Addendum # 2

Bid Opportunity: 25-7630-RFT - Laurentian Public School HVAC and Building Controls Upgrade

SHEET NO. :A102

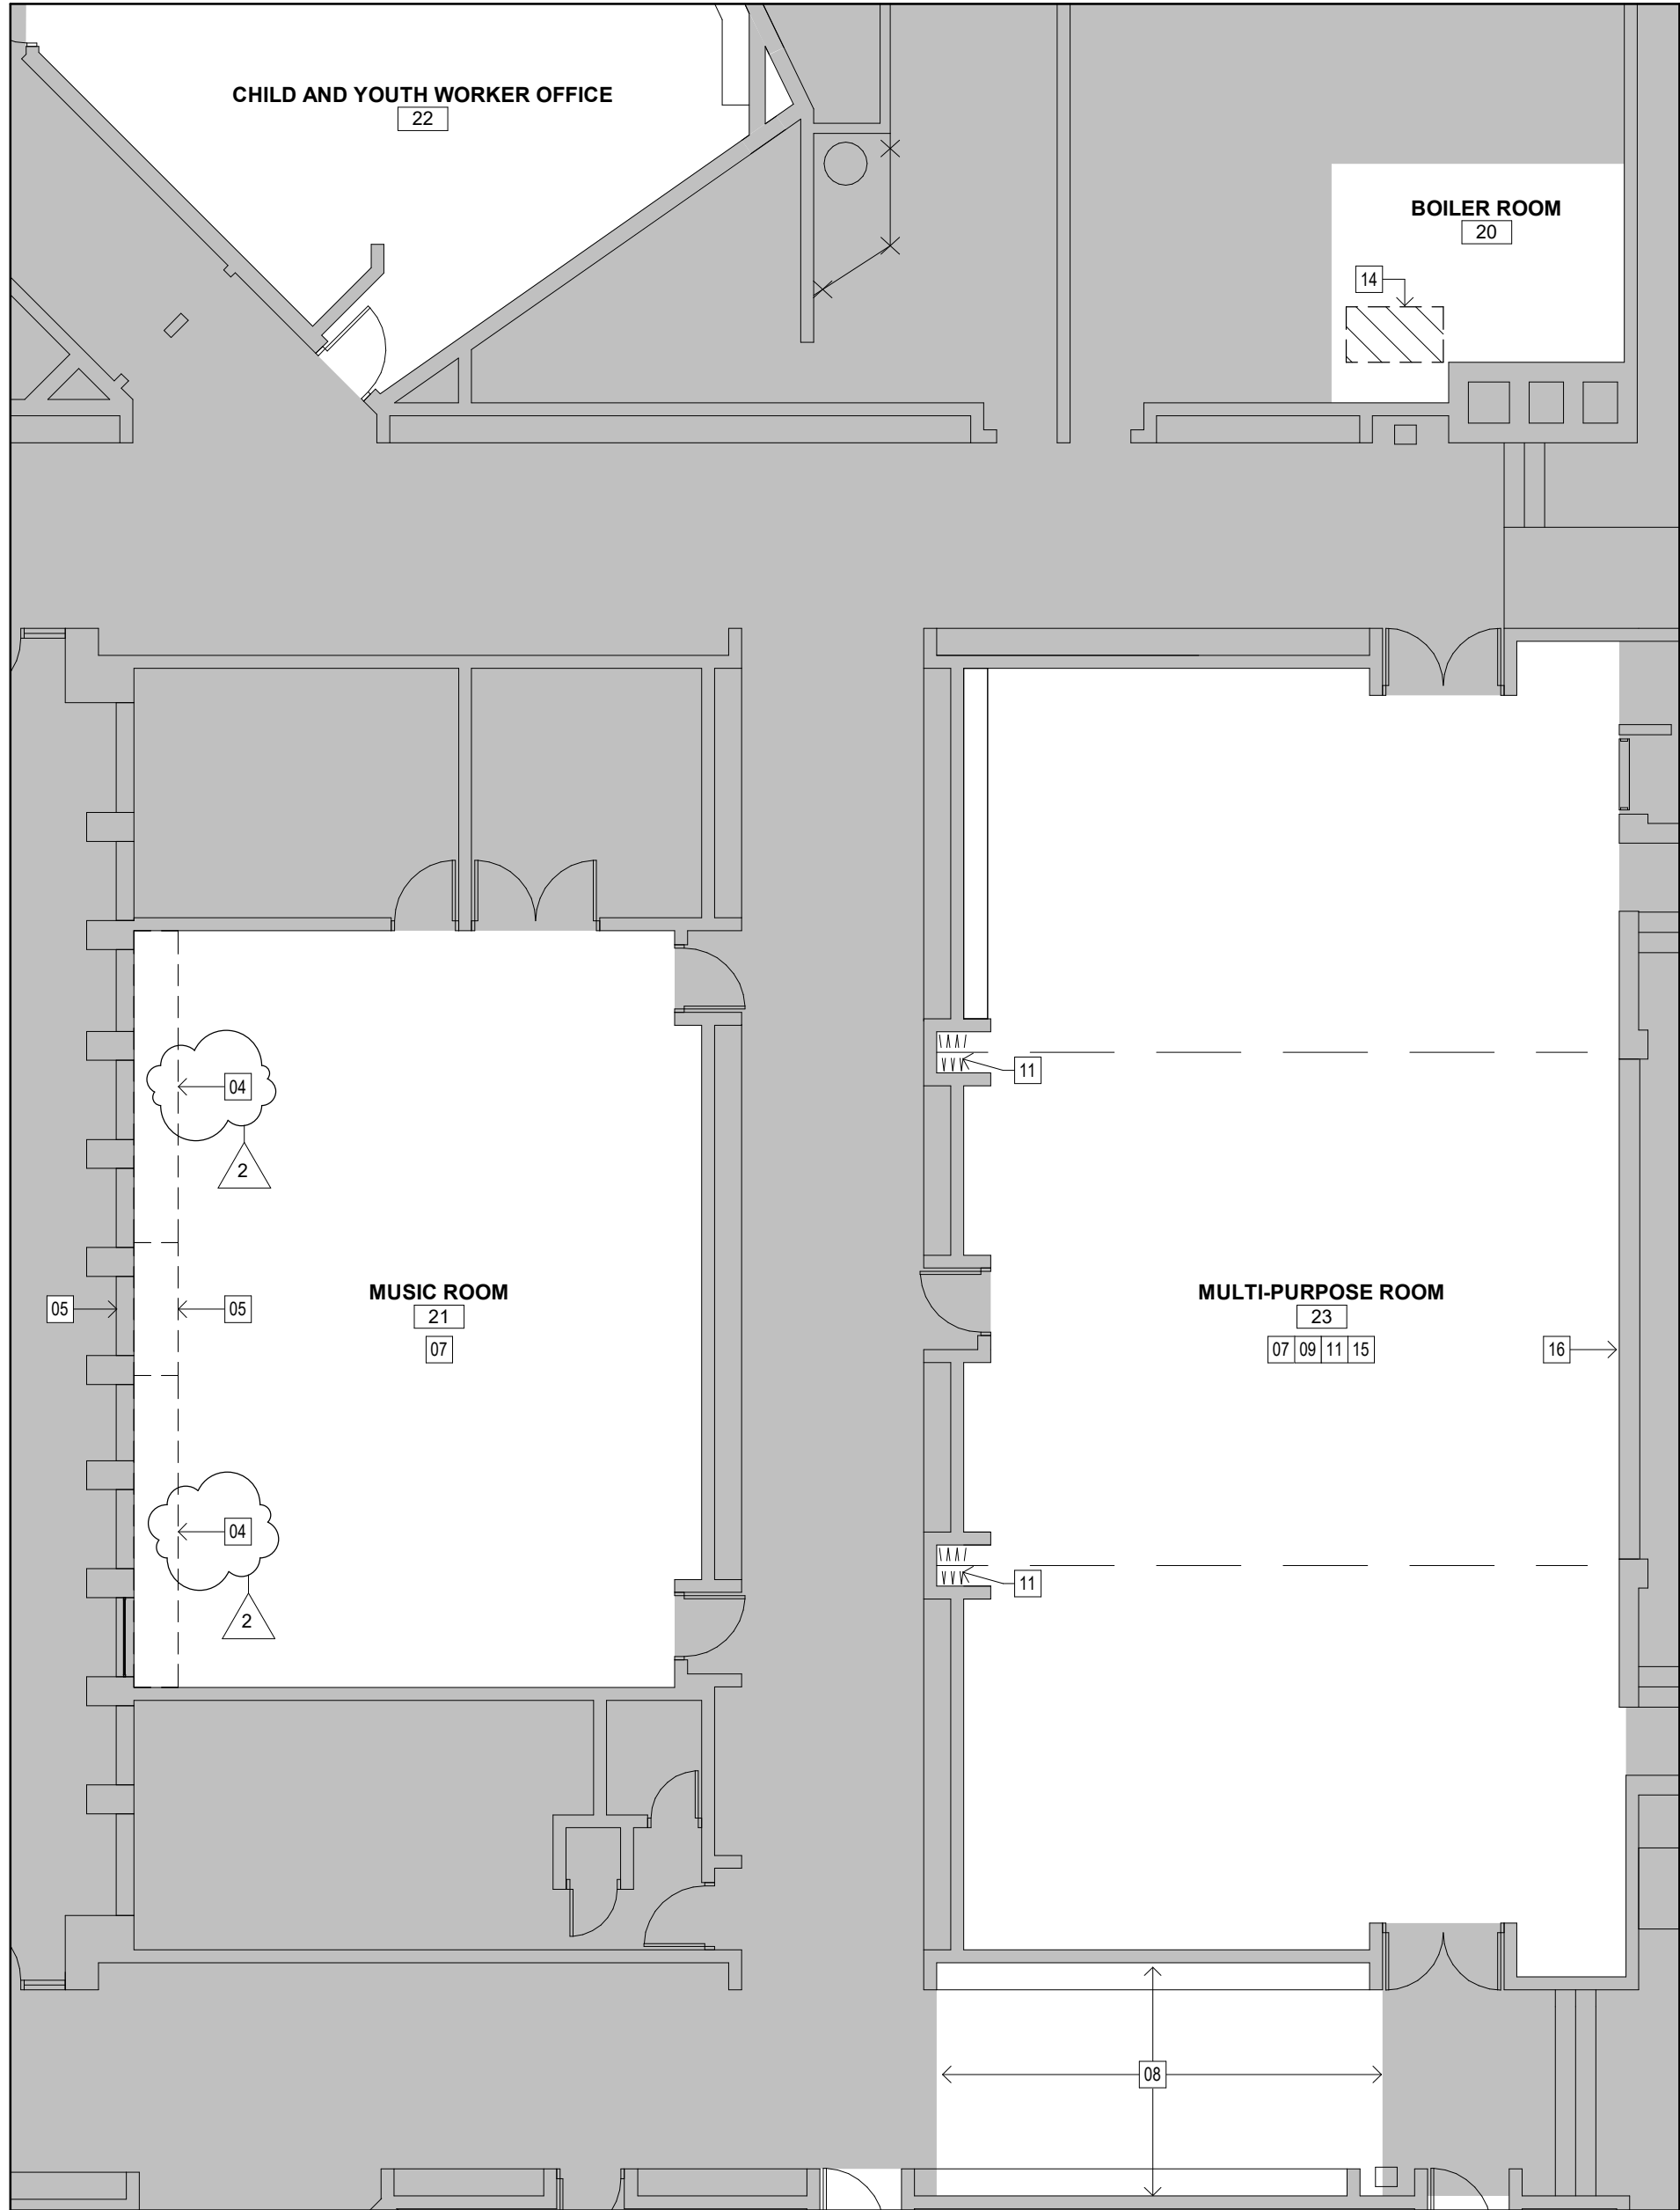
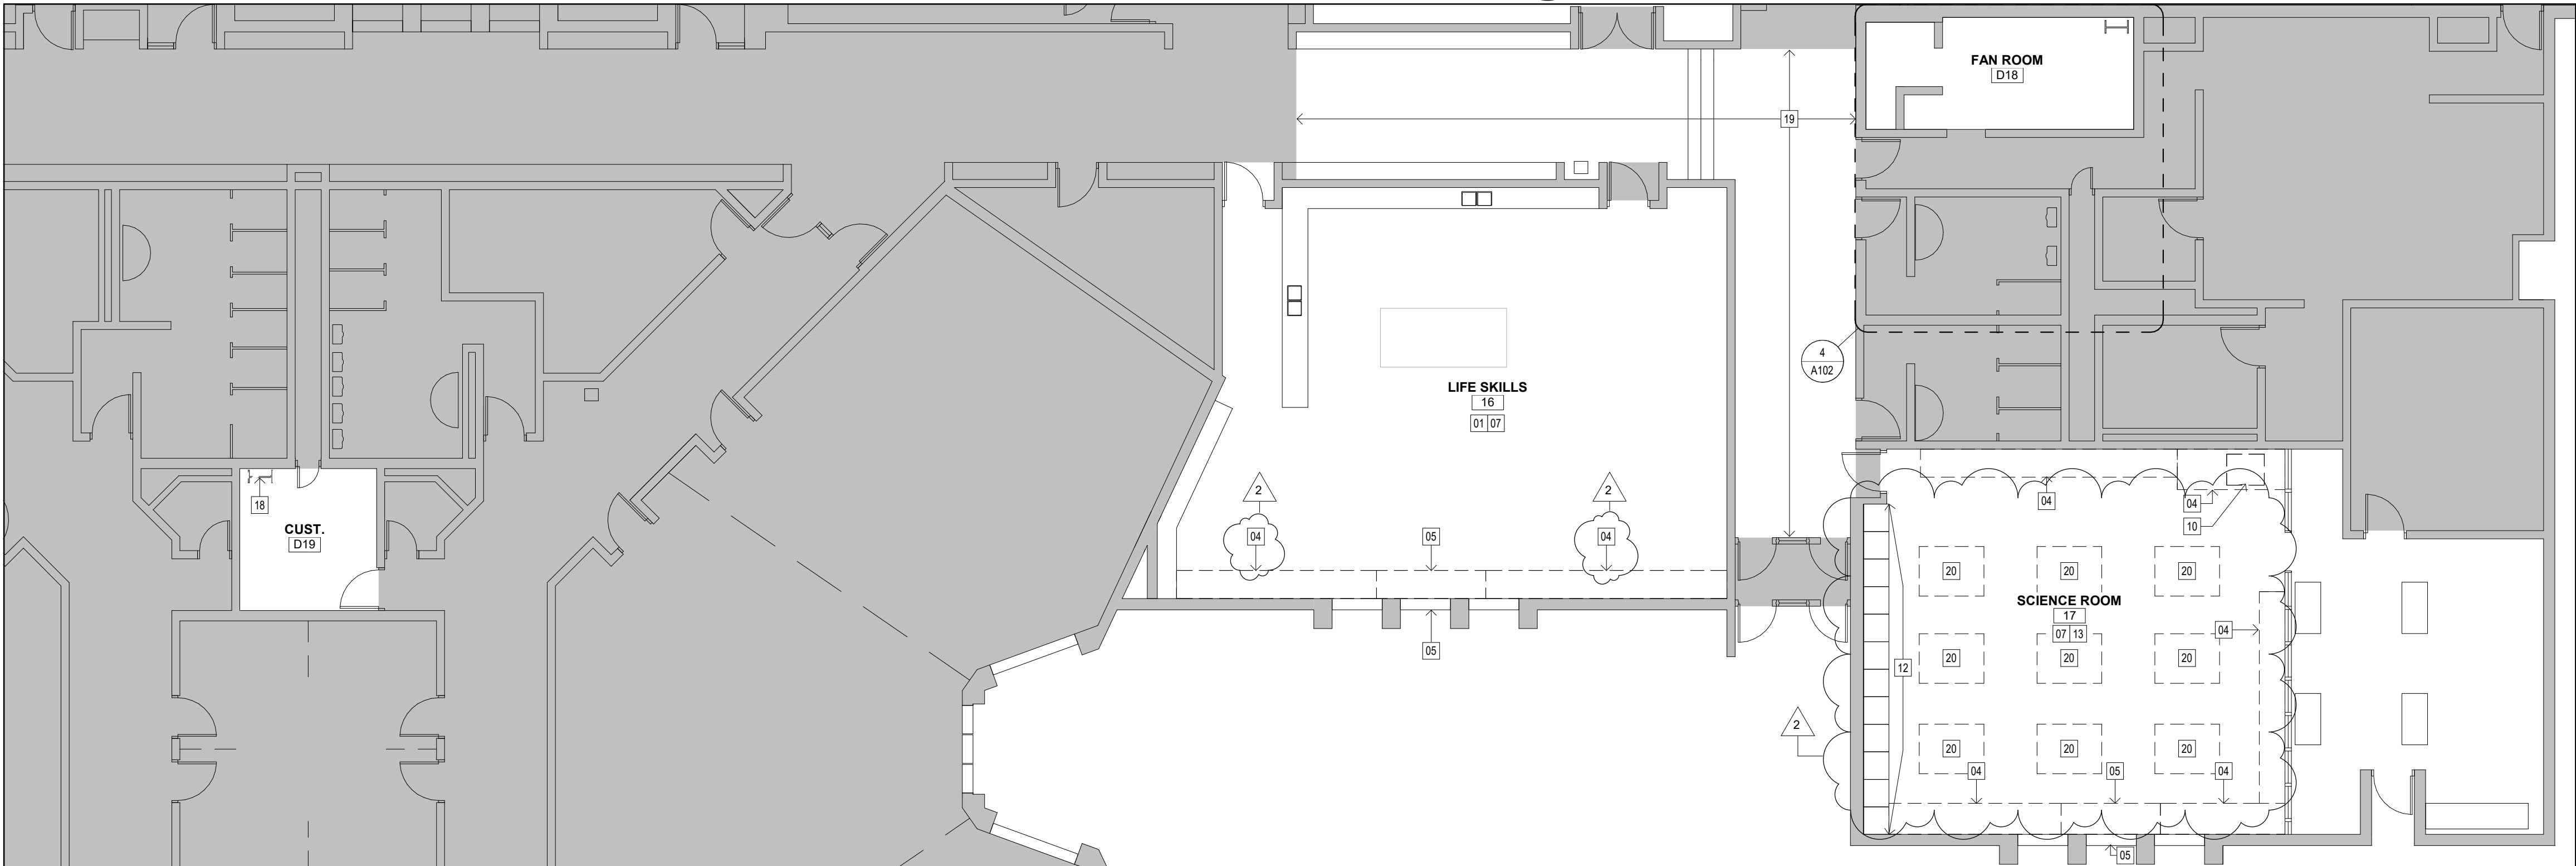
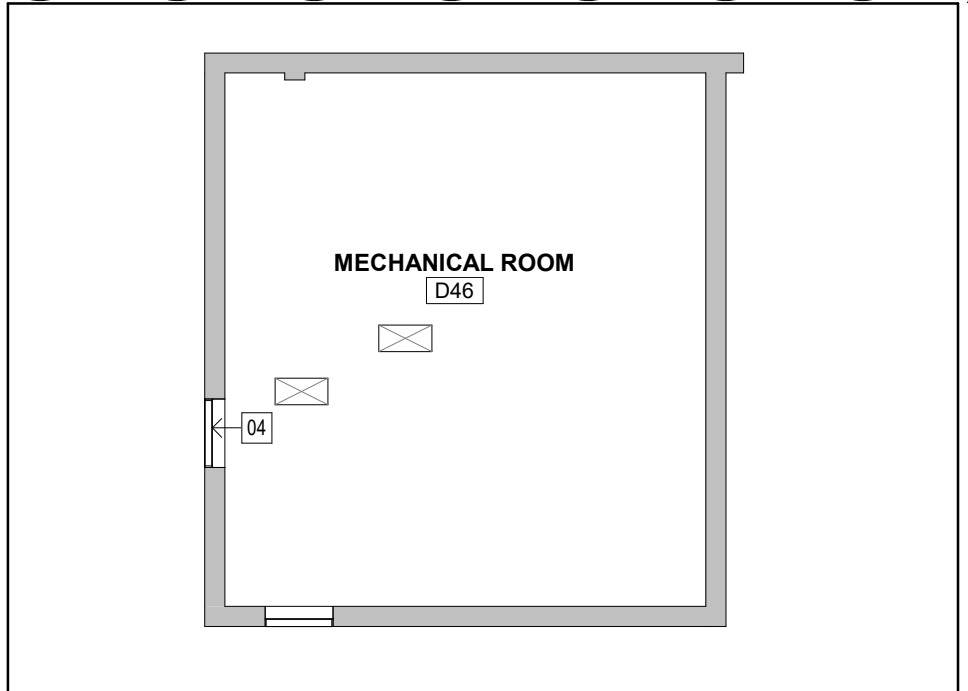
Temporarily remove benches, refer to changes to architectural drawings A102 and A202 in this addendum.

CHANGES TO ARCHITECTURAL DRAWINGS**Drawing A102 Partial Ground Floor Plan Demolition Plan**

1. In Life Skills Room (16), Science Room (17) and Music Room (21) revised demolition note 03 to demolition note 04. See attached drawing A102.

2. In Demolition Notes added demolition note 20 'Temporarily remove benches and store on site to allow for re-finish of wood floor. Refer to electrical demolition drawings E301 for electrical disconnect of receptacles.'
3. In Science Room (17) added benches and demolition note 20 to benches.

- TEMPORARILY REMOVE BENCHES AND STORE ON SITE TO ALLOW FOR RE-FINISH OF WOOD FLOOR. REFER TO ELECTRICAL DEMOLITION DRAWING E301 FOR ELECTRICAL DISCONNECT OF RECEPTACLES.
